Product Change Notification (PCN)

PCN Number	508179	Date Issued	June 11, 2020
Reason for Change	Capacity change or tool replacement		
Change Type Description	This letter is to inform you that another set of tooling is being added to meet the current and future demands of this product. There will be no changes in the fit, form or function from the additional tooling when compared to the current tooling.		
Reason for Short Notice	New Capacity		
Assessment of Change	Product will be fully qualified before it is shipped. Qualification reports will be available after below listed date		
Internal Molex Qualification Date	June 15, 2020		
Sample Availability Date (Changed Part)	June 15, 2020		
Planned Implementation Date	June 25, 2020		
Method of Identifying Change	Date code

Impacted Products Images

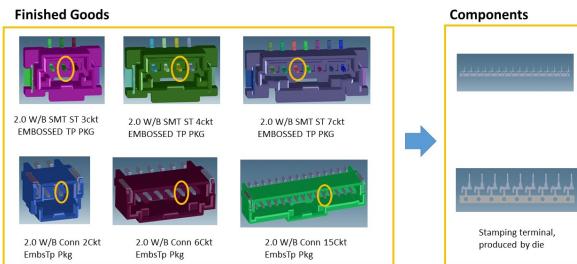
- Make new die for expanding capacity to meet customer demand.
 - Molex will build new two sets dies. Current die type are 1 line *2ups. New dies type are 2 lines *2ups.
- Product Impact: No impact to fit, form or function
- Part Number Impact: see attached impacted parts list
- Qualification reports and samples available upon request
